# **TRANSIT EFFECTIVENESS PROJECT Final Environmental Impact Report**

**Volume 3 – Responses to Comments Attachments**

**City and County of San Francisco Planning Department  
Case No. 2011.0558E**

Figure 1: Topological map of the 60 block area from which the predominant number of the riders of the #3-Jackson come or go.

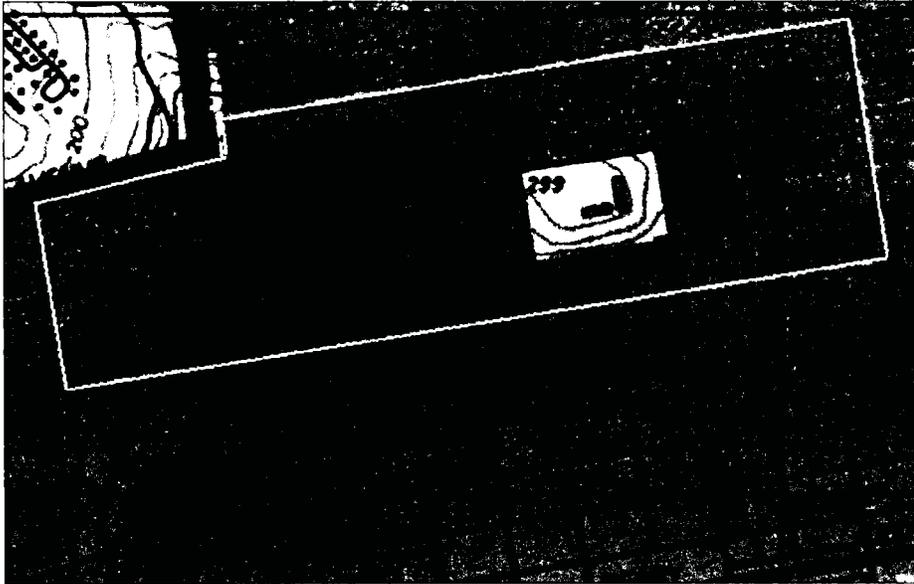
We define a sixty block area in Pacific and Presidio Heights as the affected neighborhood (see Figure #1). There are four unique attributes which need to be considered in any analysis of the impact of eliminating the #3-Jackson on the quality of our environment. They are:

- **Topography** – our neighborhood is very hilly. Jackson crests at about 350 feet at Lyon Street and then drops off along either side to, for example, 150 feet at Sutter (please see Figure #1). Steep hills are not easy for the elderly to negotiate.

Figure 4: Plot showing where a random group of the over 1000 petition signers lived in our 60 square block community.

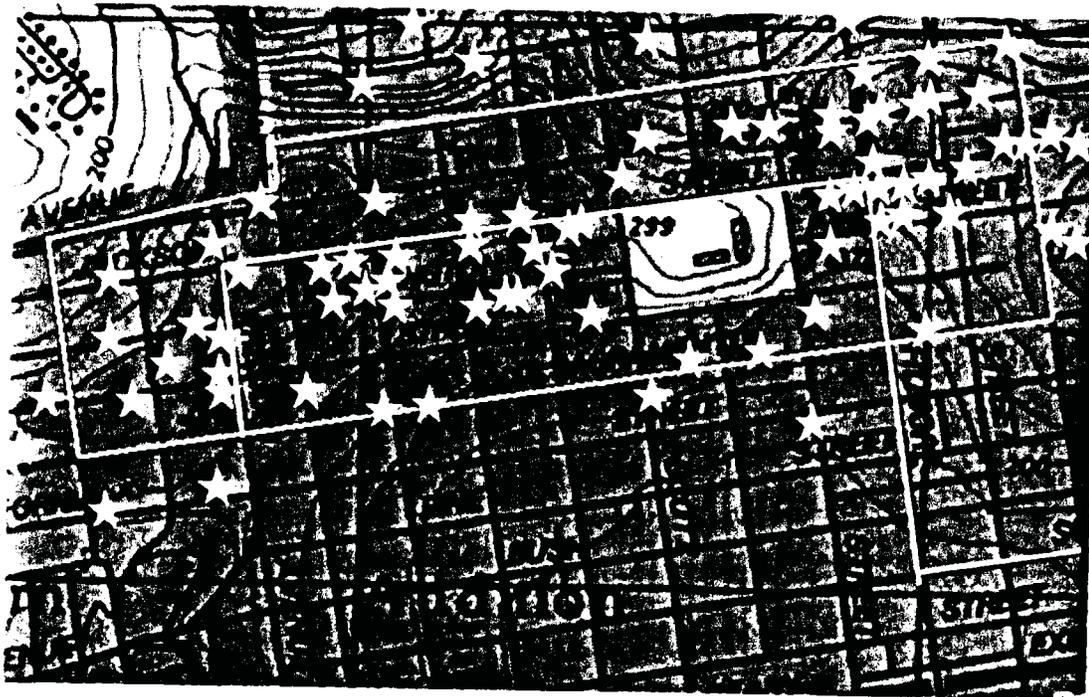
The following (see Figure #4) is a small sample of the over 1000 signators showing the location of those that lived within the Community (about 53% of those that signed the petition gave addresses within the 60 block area).

Figure 1: Topological map of the 60 block area from which the predominant number of the riders of the #3-Jackson come or go.

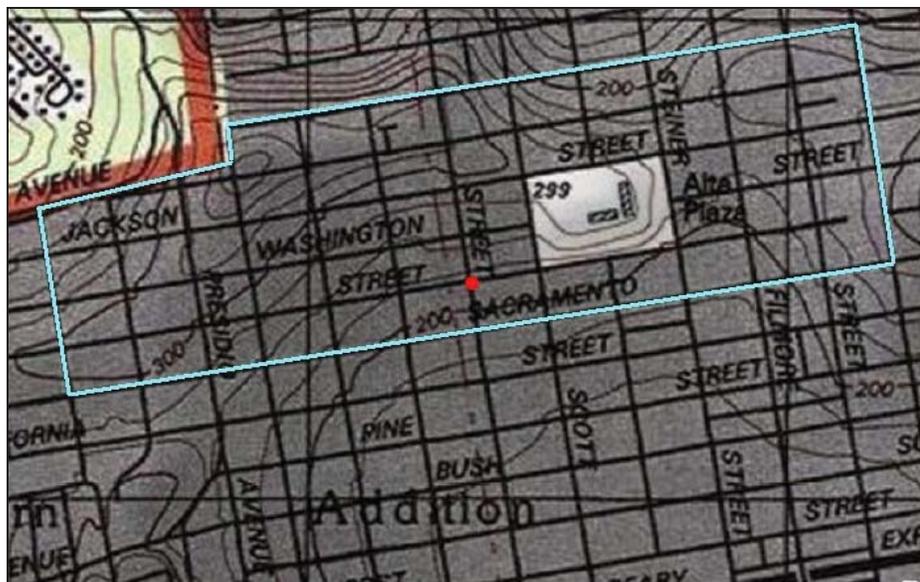
We define a sixty block area in Pacific and Presidio Heights as the affected neighborhood (see Figure #1). There are four unique attributes which need to be considered in any analysis of the impact of eliminating the #3-Jackson on the quality of our environment. They are:

- **Topography** – our neighborhood is very hilly. Jackson crests at about 350 feet at Lyon Street and then drops off along either side to, for example, 150 feet at Sutter (please see Figure #1). Steep hills are not easy for the elderly to negotiate.
